P5023A-03-S

Safety Service Note

P5023A Keysight Streamline USB Vector Network Analyzer

“POTENTIAL BURN INJURY (HIGH TEMPERATURE) HAZARD”

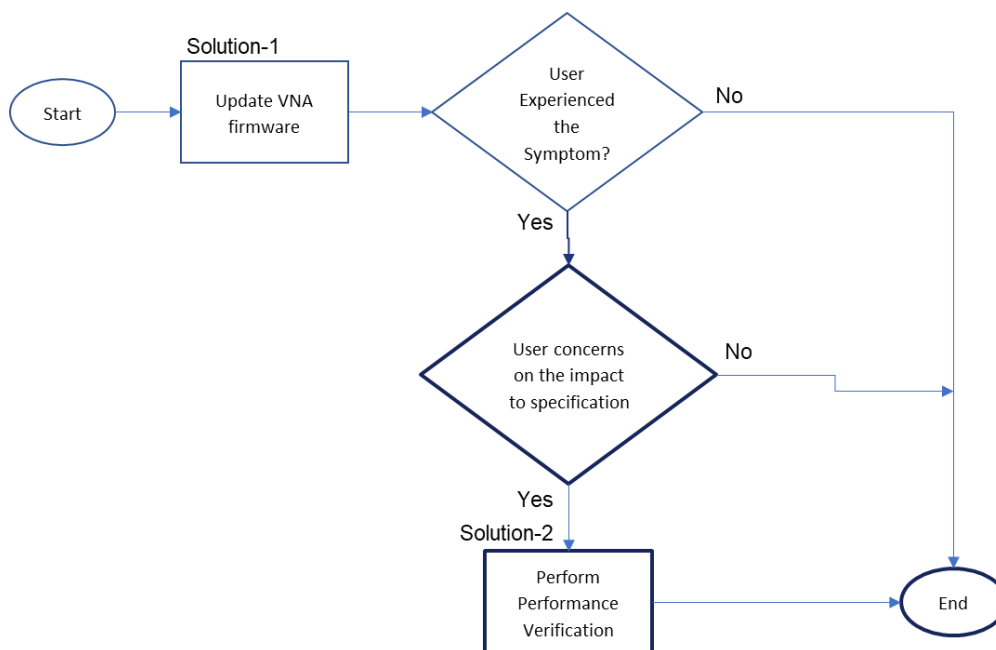
Symptom:

VNA fails to start with the following symptoms.

1. LED indicator (below circle) turns red.
2. cooling fan does not work
3. If user leaves the VNA with this LED indicator red without turning off power switch, it continues to overheat and becomes too hot.

Solution-1: Update VNA firmware by user

Action-1: Updating the firmware eliminates this potential risk of overheating.

1. **Install the latest VNA firmware Rev. A.15.40.13 or newer on users' controller PC(s).**
The latest firmware enhanced the thermal fan control mechanism.
2. Once the latest firmware is installed, proceed with the restart of both **controller PC** and **VNA**.
3. Launch the VNA firmware. Ensure VNA powers up and launches into firmware correctly after firmware update is done.
